OFFICE OF SPECIAL PROJECTS

Subject: TECHNICAL REVISION to OMLR for Permit M-2013-064 – Varra–
Coulson Resource Project – Status, Clarification, and Necessary Changes
to the GRADING PLAN and correlated Financial Warranty.

This Technical Revision is intended to clarify planned grading and attending financial warranty considerations for Middle Field and South Field, for Permit M-2013-064, only. This Technical Revision clarifies, updates, and amends prior submittals and Annual Reports.

OTHER REVISIONS/CORRECTIONS (NOTE: Slight variations from original measurements exist as reflected here below) **(REVISED IN REPLY TO ADEQUACY REVIEW #1:**

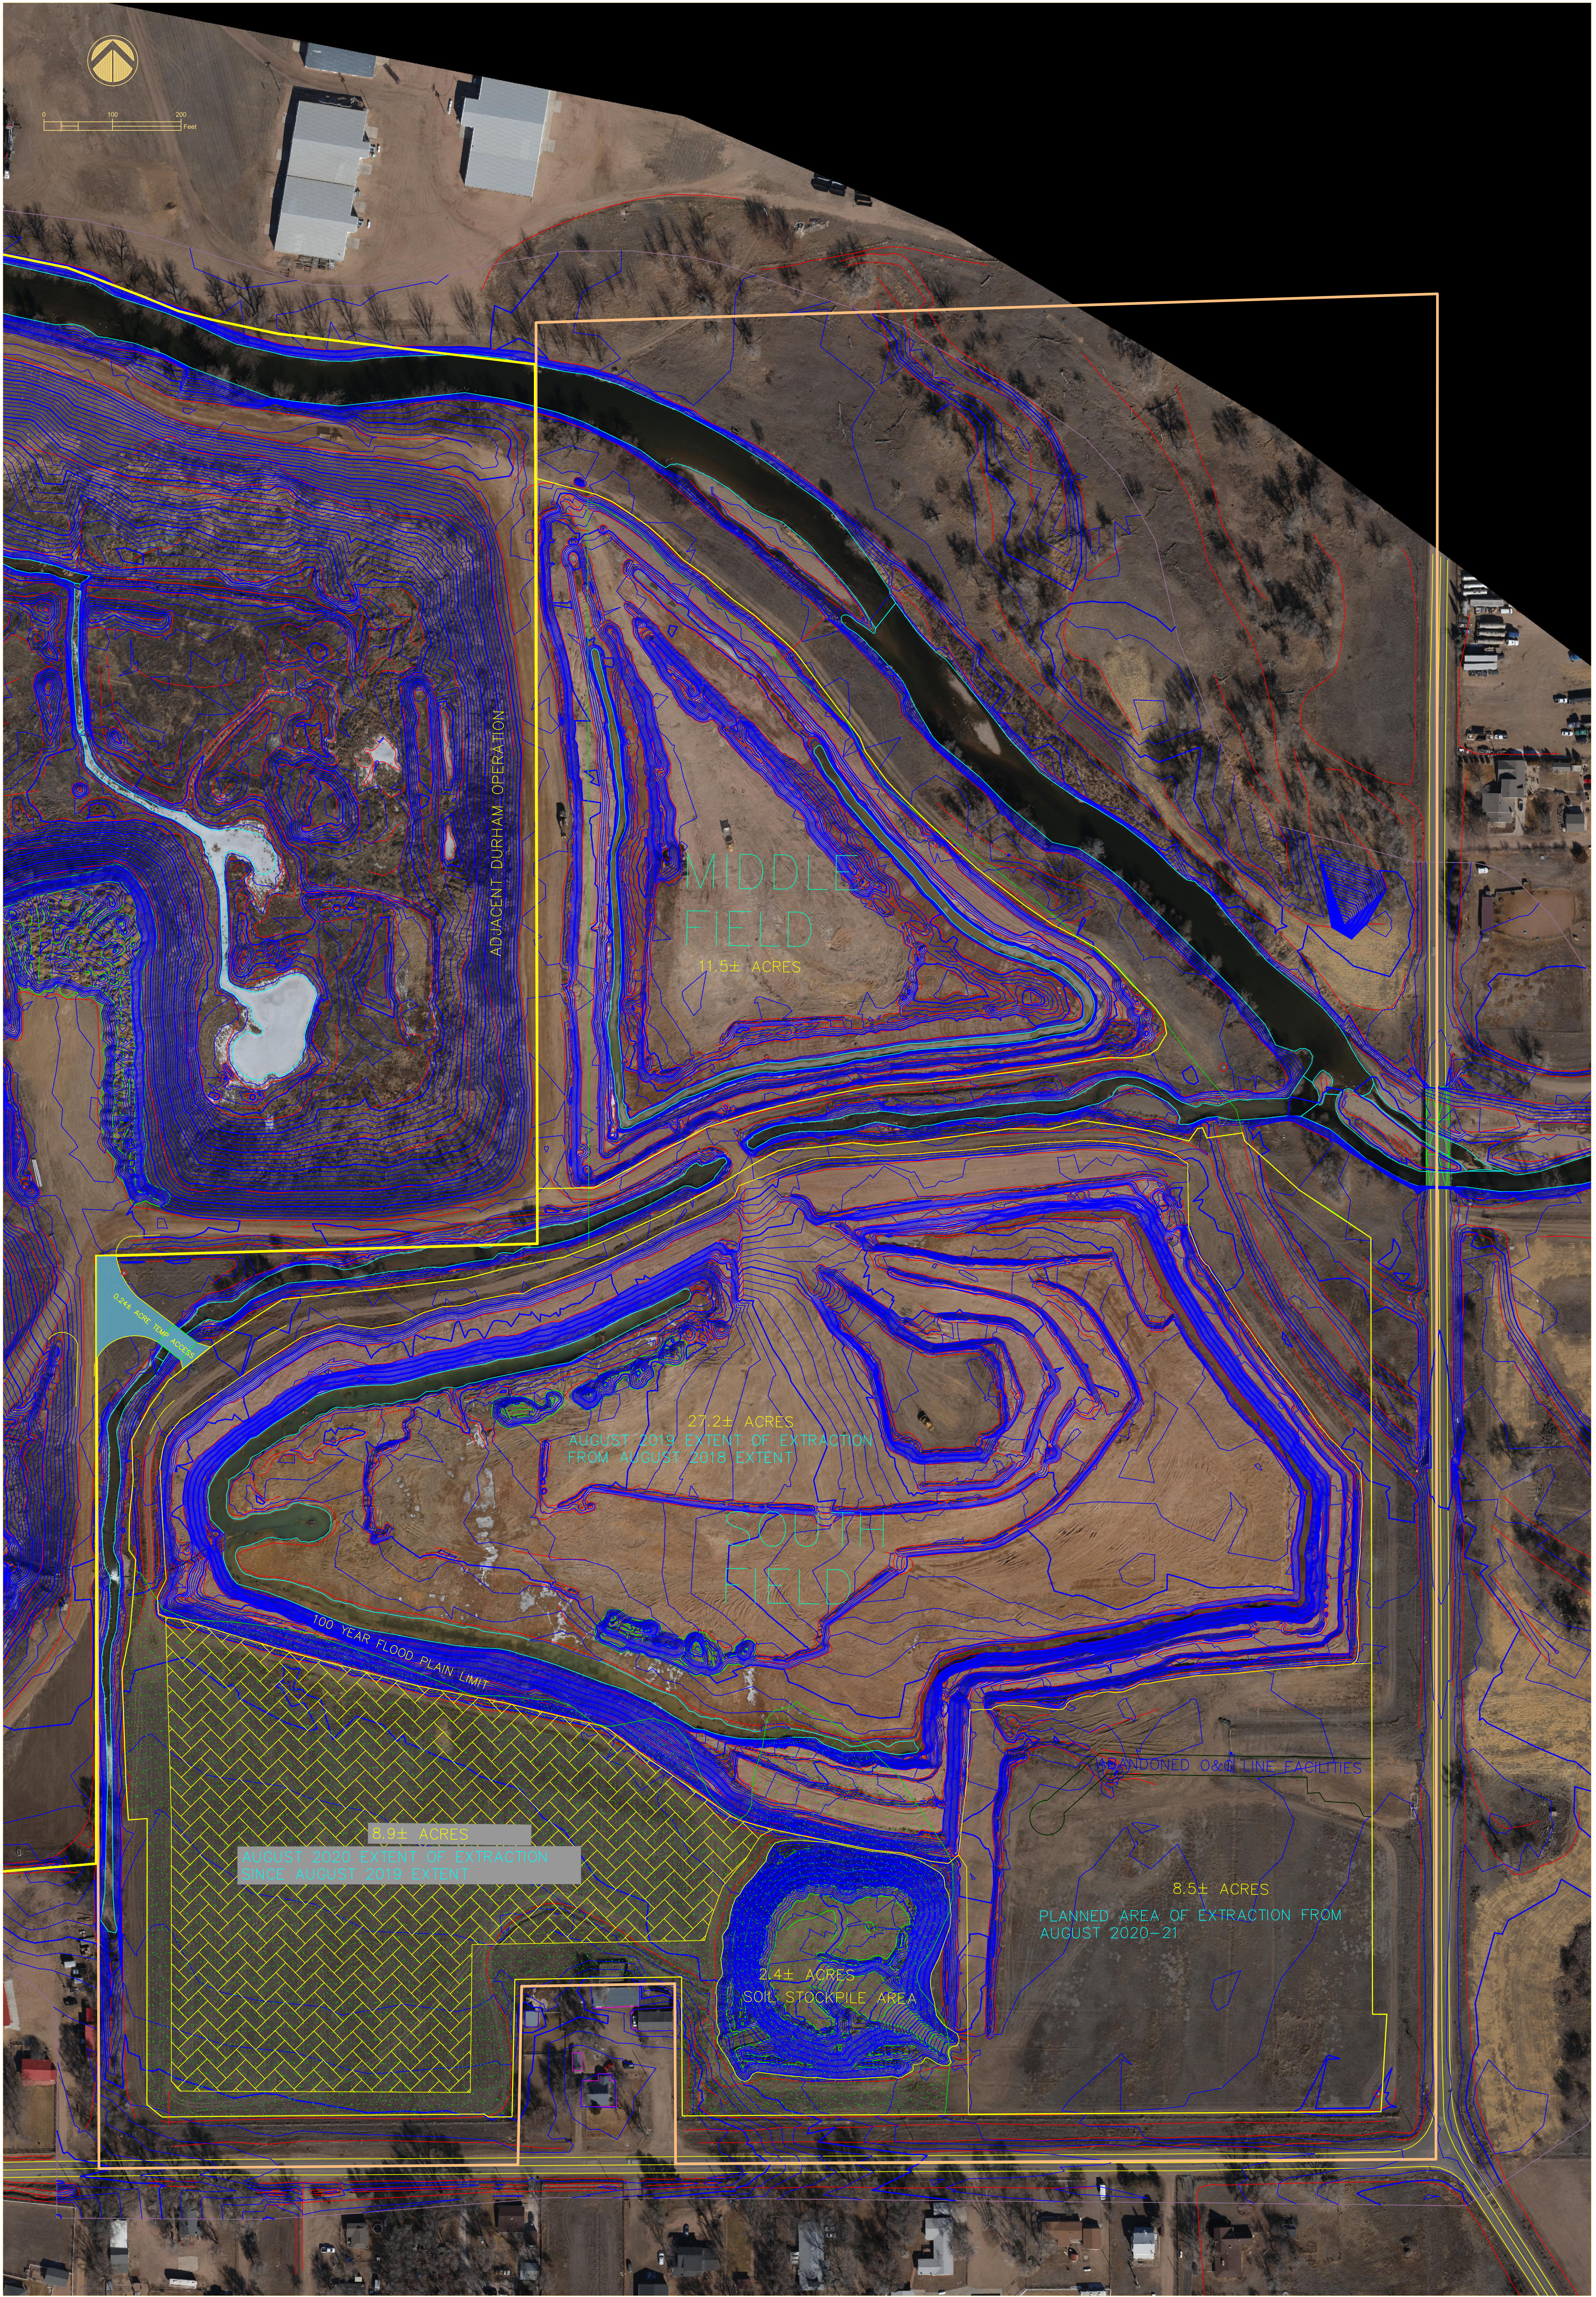
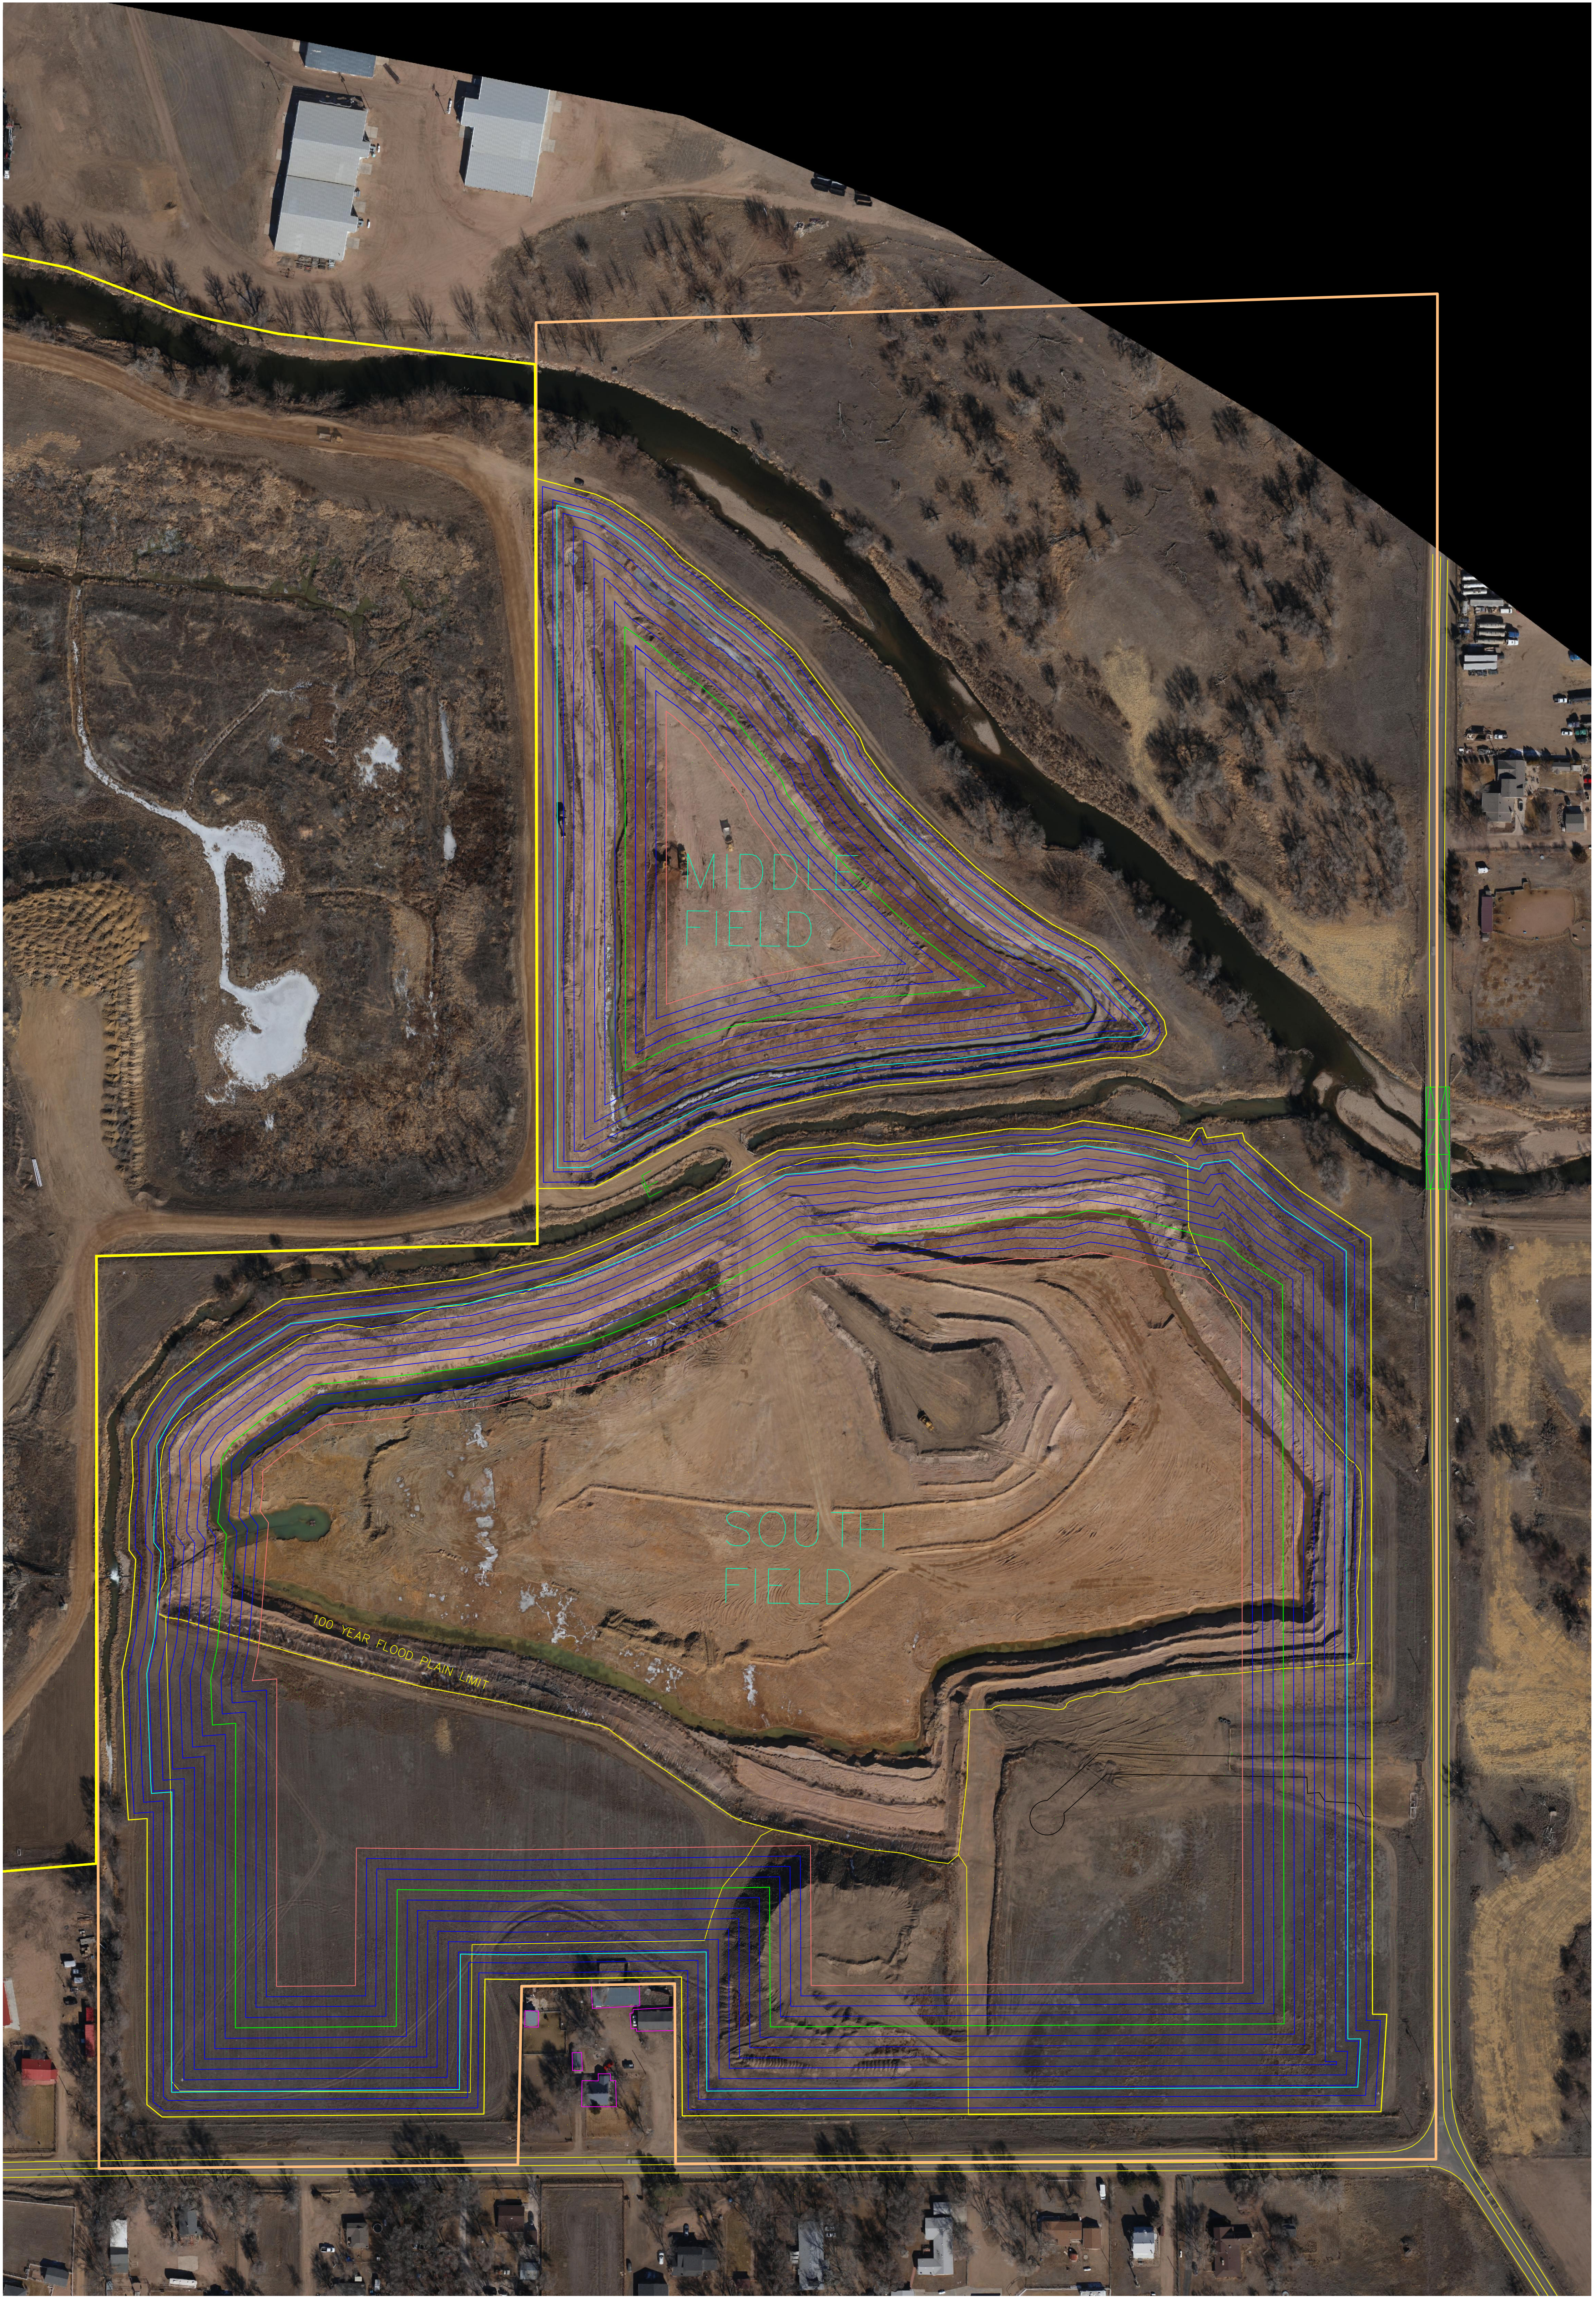
53.36±	Acres Extraction – South Field This Area now includes 0.45± acres of the Abandoned Oil & Gas Area shown in Red at South Field for the Area to be extracted as indicated in the 2019-20 OMLR Annual Report.

12.24±	Decreased by 0.68± Acres (11.56± Acres) - Extraction – Middle Field which now includes the 1.98± (now 1.806±) Acres designated for the Reconstructed segment of Canal #3 (now excludes 0.18± acres within the Poudre River 100± foot set-back area – AND increased setback from Canal #3).

65.60±	(now 64.92± Acres) Sub-total
10.75±	Acres Mineral Reserve – North Field – unchanged
76.35±	Sub-total Acres designated for Extraction
24.28±	Increased by 0.68± Acres (24.96± Acres) - Affected Lands beyond planned extraction limits (which includes temporary access of 0.24± Acres – and that portion of Canal #3, previously designated for extraction; as shown on the Exhibit C-2: Extraction Plan Map revision.

The included Maps is enlarged at 1 inch = 100 feet to better reflect the measurements and locations of features utilized to determine fill volumes needed to bring the reclaimed basin slopes from the current mean extracted slopes of 2.5H:1V± to a 3H:1V± grade as determined for the completed perimeter area reflected on the revised Extraction Limits of South Field and Middle Field.

~~\$ 70,681.68±~~ The Operator consents to the OMLR estimated
\$ 137,199.00± Warranty Increase needed for the Revised Grading Plan.
